<b>Licence Number</b>	L8889/2015/1
<b>Licence Holder</b>	Eastern Metropolitan Regional Council
<b>File Number:</b>	DER2015/000777-1
<b>Premises</b>	Red Hill Waste Management Facility  Legal description – Lot 1 Diagram 15239, Lot 2 on Diagram 68630 and Lot 11 on Diagram 69105 Toodyay Road Red Hill and Lot 12 on Plan 26468 Toodyay Road, Gidgegannup
<b>Date of Report</b>	26/06/2020
<b>Status of Report</b>	FINAL

### 2.1. Purpose and scope of assessment

On 14 April 2020, Eastern Metropolitan Regional Council (the Licence Holder) submitted an application to the Department of Water and Environmental Regulation (DWER) to amend L8889/2015/1. The Licence is for the Red Hill Waste Management Facility, a prescribed premises for the following categories:

Figure 6: Stage 1 hardstand and leachate sump design cross-sections

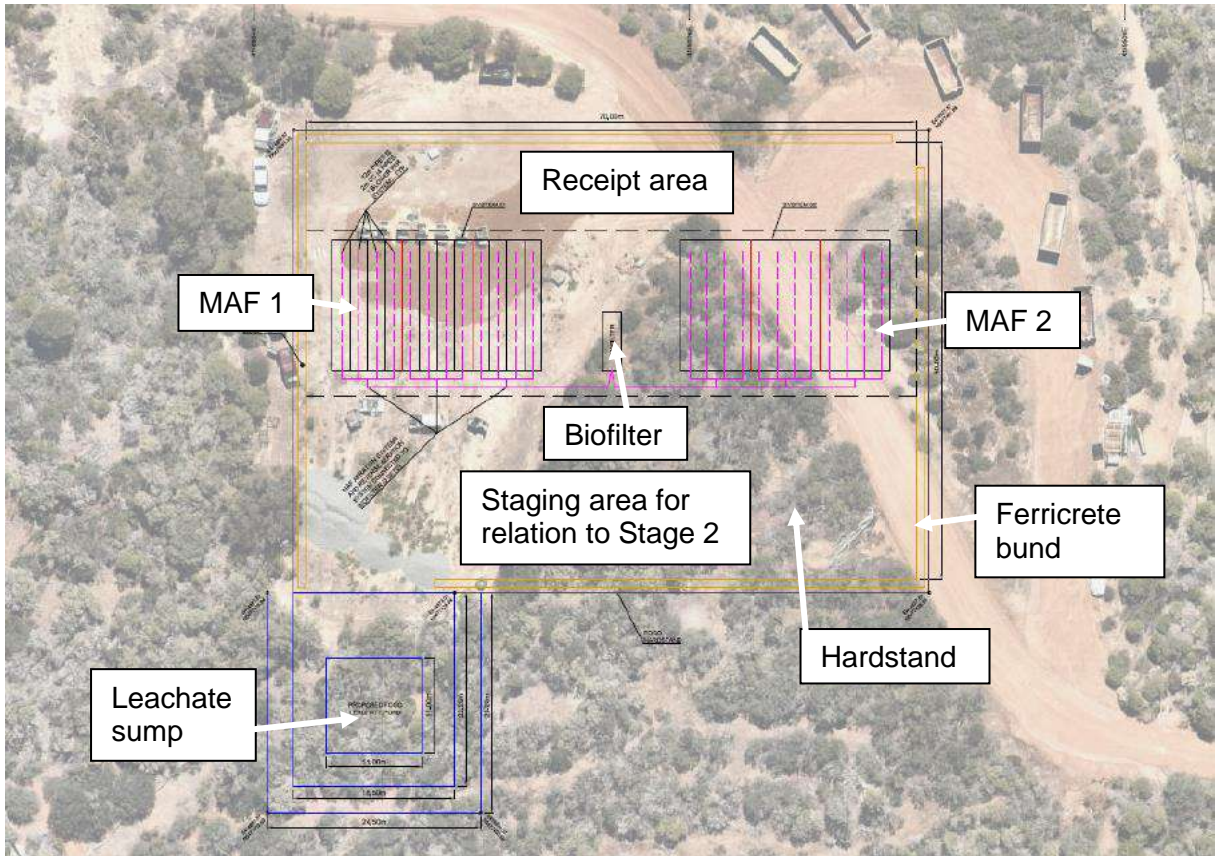
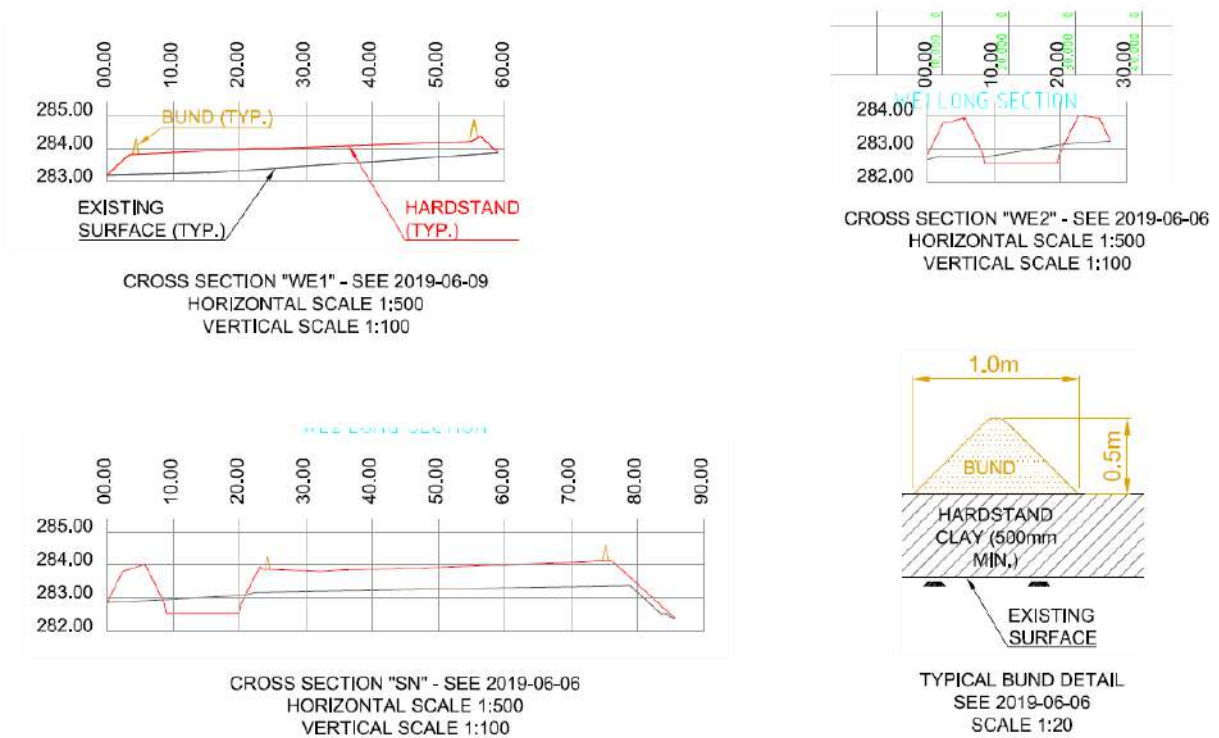
- 9) The Delegated Officer considers that a fall of 0.8-1% may not provide sufficient drainage of leachate to the sump. To avoid pooling of leachate, the Delegated Officer considers that a grading of at least 2% would be more effective to prevent pooling of leachate.

Construction of the sump will involve excavating to approximately 0.4 m below the existing ground surface (Figure 6). DWER is not aware of whether this will affect the capping layer or only require excavation of shallow fill materials.

Figure 8: Stage 2 FOGO equipment and infrastructure layout

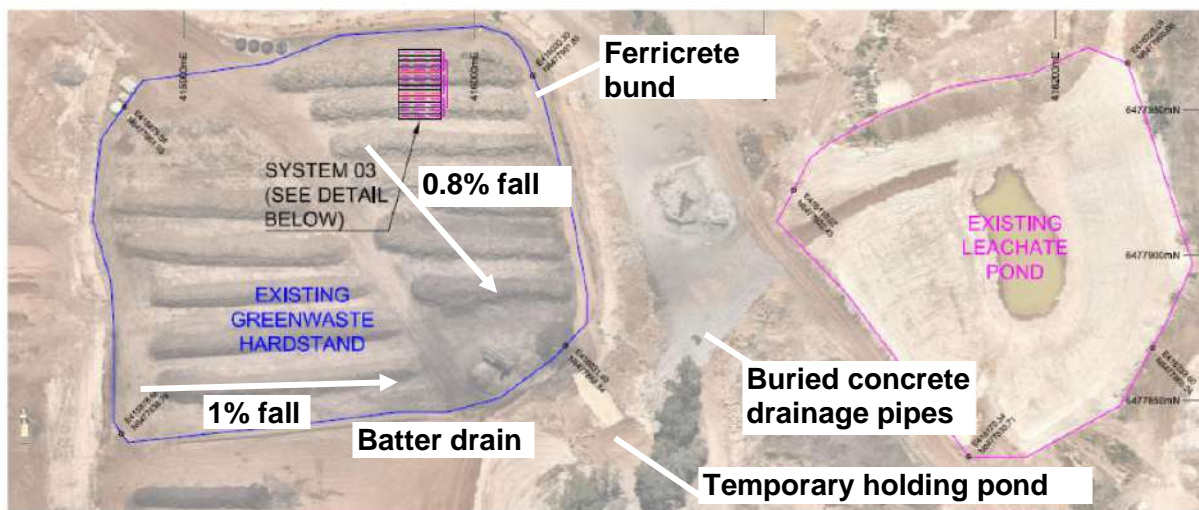
- 16) Aerial imagery of the premises shows the green waste processing hardstand was close to its maximum storage capacity on 8 March 2020 (Figure 8). However, the Licence Holder considers that there is sufficient space on this hardstand for Stage 2 FOGO composting and equipment including one MAF system and a trommel screen.
- 17) The temporary laydown area is not suitable for the storage of final compost products. The reasons for this determination were outlined in the Amendment Report dated 30 March 2020 and further discussion of this matter is provided in Section 5.1.2.
